TE Connectivity

Product Change Notification: PCN-22-136415

A91 - Circular Commercial Connectors COVER 90DEG A91 - Circular Commercial Connectors ABDECKKAPPE 90GRD

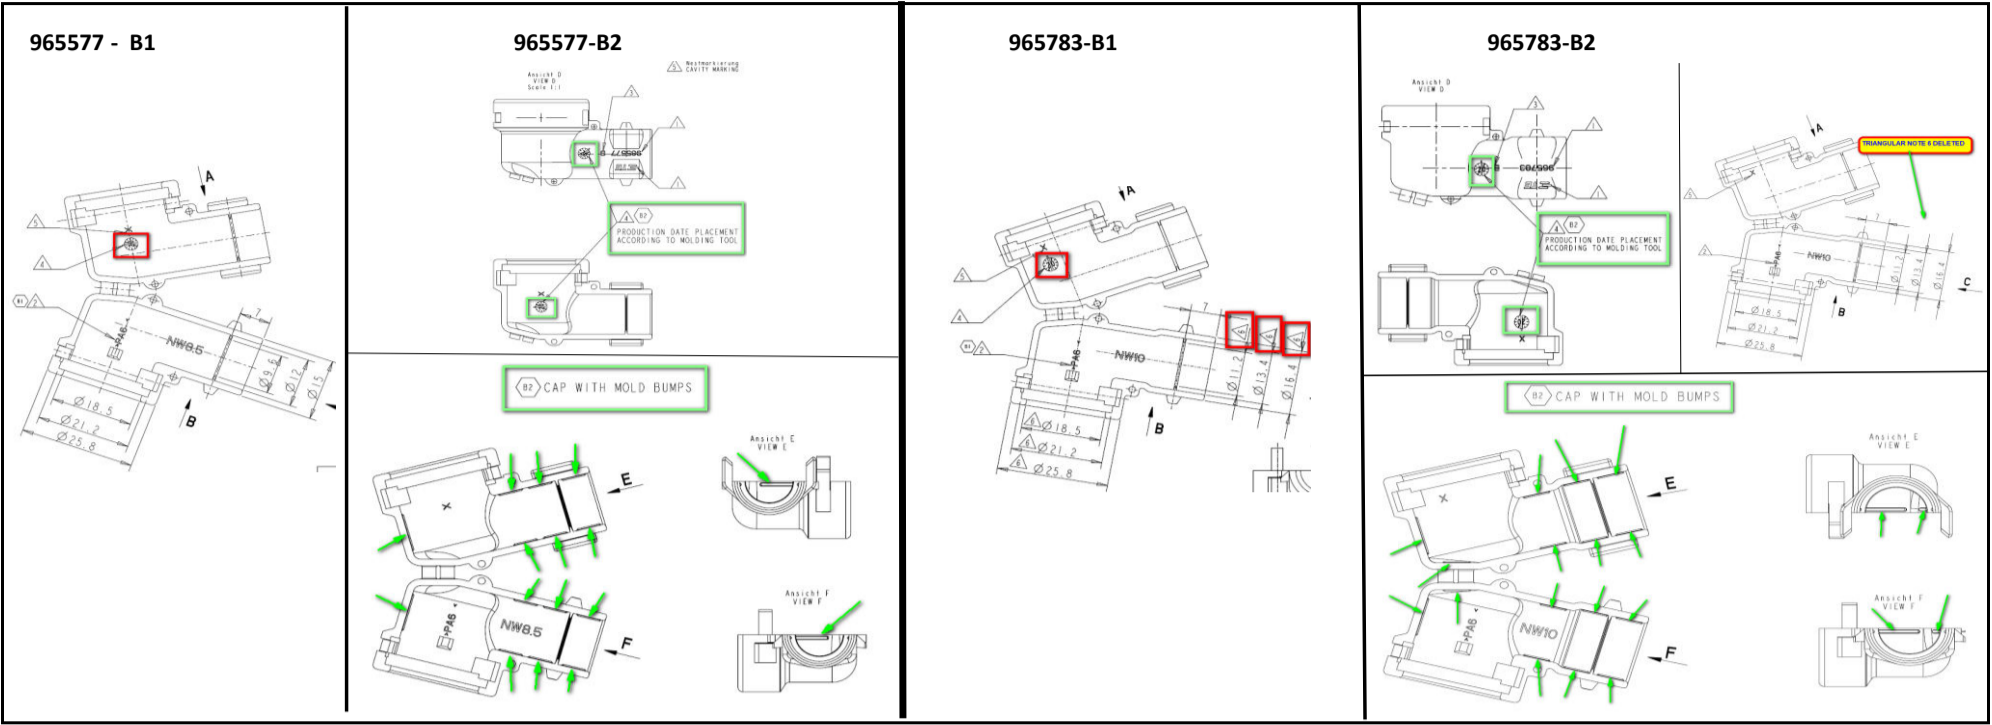
The Industrial and Commercial Transportation business unit of TE Connectivity is making a minor drawing change to show the views of the caps with mold bumps and the new date clock placement for the product drawings listed below. 965577 965783

x	Potential Impact for Customer	x	Product Type	x	Change Type	x	Kind of Change	x	Change Feature	Remark / Free text
x	Revision adapted	x	CAPS/COVERS AND COVER ASSEMBLIES	x	No Form, Fit, Function	x	Drawing	x	Drawing Change	Mold bumps added along with new date placement.
